## COMMENTS ON THE TESTING PROCEDURES

-Draft report: ACSF 04-19

<b>CAT E system</b>								
FU1	FU2	EM1A	[EM1B]	EM2	TR1	TR2	TR3	TR4
curved track	straight track	straight track	straight track	straight track	curved track	curved track	straight track	curved track
Lane keeping	Lane change	braking target	slow moving target	stationary target	lateral acceleration exceeded	missing lane marking	two objects on different lanes	failure in a curve
<u>Tests necessary:</u>								
D								
J								
SE								
NL								
EC								
ROK								
OICA								
CLEPA

### FU1: Functionality Test 1 (FU1): ACSF 04-20

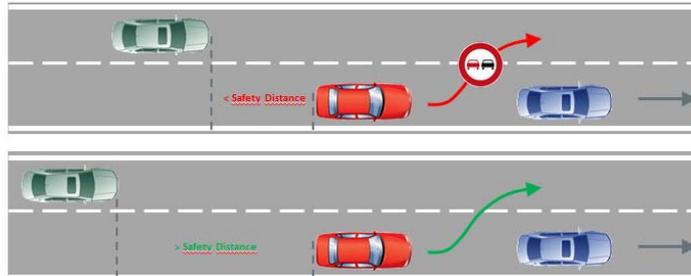
**Comments:** Needs to have about a 5 km section of highway with curves traveled continuously at various speeds between  $v_{smin}$  and  $v_{smax}$ . (Which Technical Service has this facility?).

**Additional comment:** Is the lead vehicle can be used to prevent from seeing the markings?

**Proposal:** To have as alternative the possibility to perform the test:

- either on a road circuit with the possibility to travel some parts (curves) at a speed  $< v_{smin}$  (if too high)
- or on a total cumulative distance of road tracks (e.g. same loop traveled at different speeds).
